# Work Order ID 63339

Item ID: D3303-041 Accept  Setup Start   
Revision ID: Stop   
Item Name: Head Rest  
Start Date: 10/27/2010 Start Qty: 2.00  Cust Item ID:  
Required Date: 11/11/2010 Req'd Qty: 2.00  Customer:  
Reference:

DESIGN <i>PH</i>	DRAWN BY <i>B</i>	<b>DART AEROSPACE LTD</b> HAWKESBURY, ONTARIO, CANADA	
CHECKED <i>PH</i>	APPROVED <i>H</i>	DRAWING NO. <b>D3303</b>	REV. B SHEET 1 OF 4
DATE <b>06.08.17</b>		TITLE <b>HEAD REST</b>	SCALE 1:3
REV	DATE	DESCRIPTION	
A	04.08.18	NEW ISSUE	
B	06.08.17	UPDATED FLAT PATTERN TO FORM PART IN ONE OPERATION USING OFFSET DIE

DRAWING NO. D3303	TITLE HEAD REST	REV. B	DART AEROSPACE LTD ENGINEERING ORDER		D.E.O. NO. D3303-B-1	SHEET NO. SHEET 1 OF 1	SCALE NTS
DRAWN AJS	CHECKED <i>h</i>	MFG. APPR. <i>AA</i>	APPROVED <i>W/D</i>		DE APPR. <i>h</i>		
DATE 08.10.15	DATE 08.10.16	DATE 08/10/16	DATE 08/10/16		DATE 08/10/16

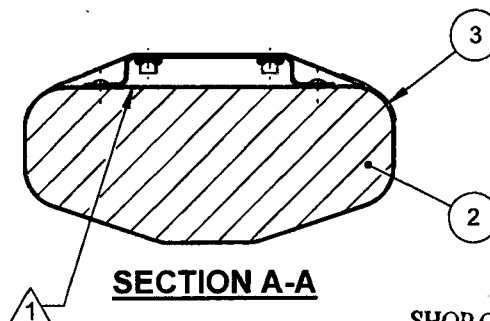
SHEET 1 ADD 1300L ADHESIVE BY 3M TO NOTE 1 AS FOLLOWS:

**IS:**

- 1) BOND D3305-1 FOAM TO D3303-043 BRACKET ASSEMBLY USING 3M 1300 OR 1300L ADHESIVE (0.002" TO 0.010" THICK) IN ACCORDANCE WITH MANUFACTURER'S INSTRUCTIONS

**WAS:**

- 1) BOND D3305-1 FOAM TO D3303-043 BRACKET ASSEMBLY USING 3M 1300 ADHESIVE (0.002" TO 0.010" THICK) IN ACCORDANCE WITH MANUFACTURER'S INSTRUCTIONS
